Access Compliance Report

Public Rights-of-Way

Intersection ID: 51356	Main Street: BRENTMOOR_DR	Cross Street: PEARL_ST	Location: S
ADA ID: 7527B90944F8	Ramp Type: BlendTrans1	Initial Pass/Fail: Fail	Overall Compliance: No
		Severity Score: 10

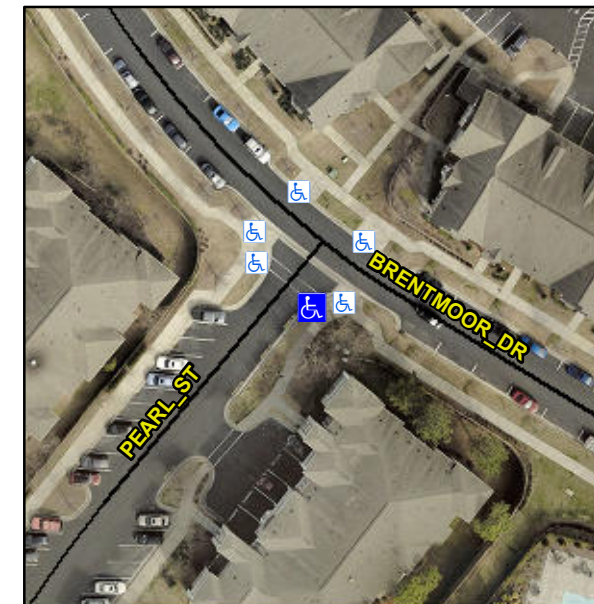
Not Found, R304.5.1, R304.5.3

Compliance	Description	Data	Compliance	Description	Data
N/A	Ramp Length (in)	75.0	Yes	BlendTrans Slope (%)	3.5
No	Ramp Width (in)	47.0	No	BlendTrans XSlope (%)	3.3
N/A	Flare Type LT	N/A	N/A	Flare Type RT	N/A
N/A	Flare Slope LT (%)	N/A	N/A	Flare Slope RT (%)	N/A
N/A	Flare Traversable LT?	N/A	N/A	Flare Traversable RT?	N/A
N/A	Landing Length (in)	N/A	N/A	DWS Provided?	N/A
N/A	Landing Width (in)	N/A	N/A	DWS Contrast?	N/A
N/A	Landing Slope (%)	N/A	N/A	DWS Length (in)	N/A
N/A	Landing X Slope (%)	N/A	N/A	DWS Full Width?	N/A
N/A	Landing Curb? (Y/N)	N/A	N/A	DWS Offset (in)	N/A
N/A	Shared Landing?	N/A			
N/A	Gutter Ponding?	N/A	N/A	Gutter Slope (%)	N/A
N/A	Gutter Lip Ht (in)	N/A	N/A	Gutter X Slope (%)	N/A
N/A	Painted X Walk1?	Yes	N/A	Painted X Walk2?	N/A
	X Walk 1 Direction	To NW		X Walk 2 Direction	N/A
	X Walk 1 Width (in)	65.0		X Walk 2 Width (in)	N/A
	X Walk 1 Slope (%)	7.5		X Walk 2 Slope (%)	N/A
	X Walk 1 X Slope (%)	1.2		X Walk 2 X Slope (%)	N/A

N/A	Ramp inside XWalk1?	Yes	N/A	Ramp inside XWalk2?	N/A
	Road Slope (%)	1.2		Clear Space?	N/A
	Road X Slope (%)	7.5	N/A	Clear Space to XWalk (in)	N/A
N/A	Any Obstructions?	N/A	N/A	Storm Grate/Utility Hazard?	N/A
	Obstruction Type			Storm Grate/Utility Type	
		N/A			N/A
			Yes	Surface Condition? (G/P)	Good
			No	Curb Slope (%)	13.1

Remove & Replace Curb Ramp With Two New Directional Ramps or Equivalent.
